SERVICE BULLETIN

APPLICABILITY: 2019-21MY Crosstrek PHEV

NUMBER: 09-82-23

SUBJECT: DTC P0452 EVAP System (CPC) Pressure Sensor/Switch Circuit Low
Design Changes to Fuel Tank Assembly & Vent Tubes

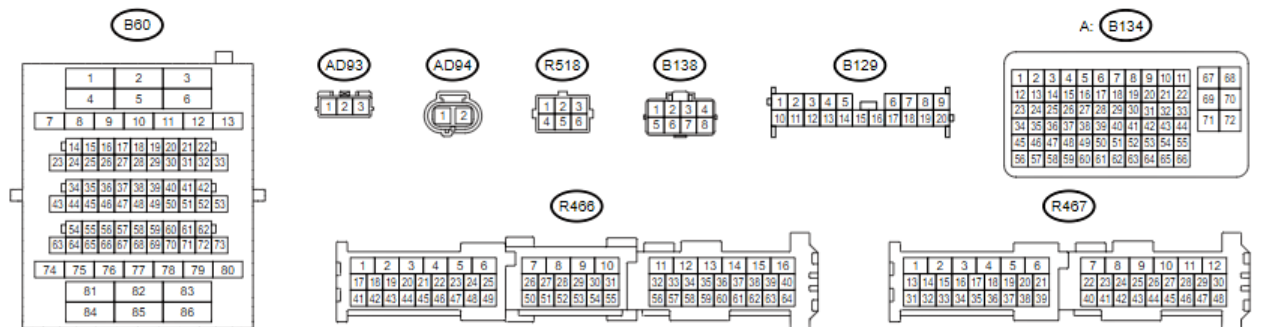
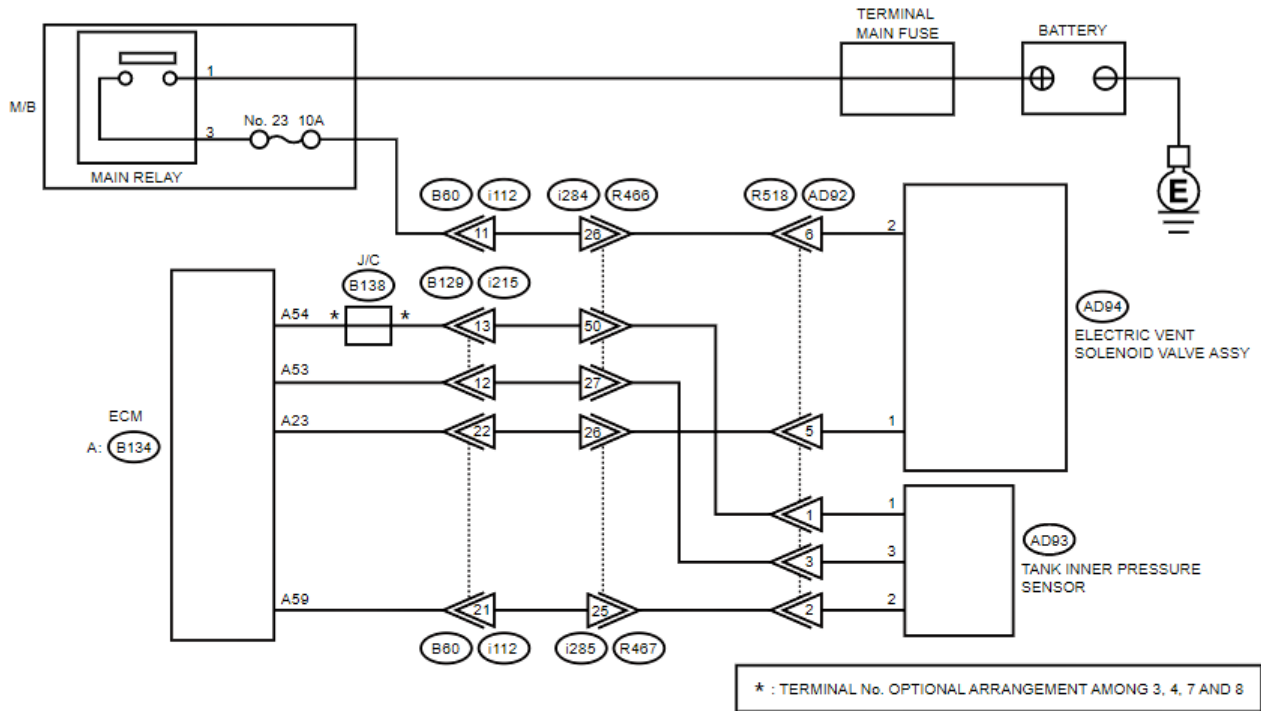
Visually inspect the internal condition of the Evaporative Line connections to the Electronic Vent Solenoid:

1. Resin Tube on the Fuel Tank Assembly (attached directly to the Vent Solenoid)
2. Vent Tube #1
3. Vent Tube #2

If any deposits/build-up is found inside the tube(s), replace all the Vent Tubes and Fuel Tank Assembly.
